Technical Service Bulletin

NUMBER: 23-16-99

Decklid Does Not Open With First Cycle Of Key Fob Operation

2000 (PL) Neon

FIGURE 1

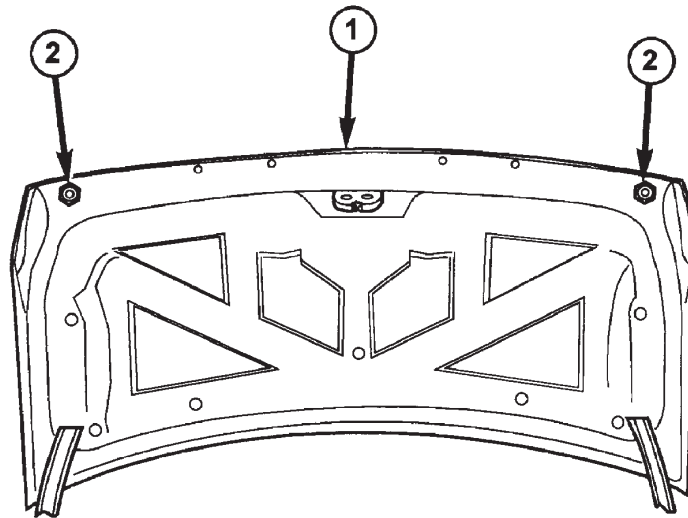
The decklid does not open after one cycle of the key fob (two button pushes), but does open after 2 or 3 cycles of the key fob button. This is possibly due to incorrect adjustment of the decklid over slam bumpers not an electrical problem with the key fob system. If the deck lid over slam bumpers are adjusted too far outward, the load on the striker prevents the latch from opening after only one cycle of the key fob.

1. Open the decklid, mark each bumper and turn each overslam bumper 1/4 turn clockwise (Figure 1 & 2).
2. Close the decklid and cycle the key fob decklid button.
3. Repeat the overslam adjustment procedure (steps 1 & 2) until one cycle of the key fob opens the decklid.

NOTE: THE OVER SLAM BUMPERS SHOULD NOT PROTRUDE MORE THAN 20MM FROM THE DECKLID INNER SHEET METAL.
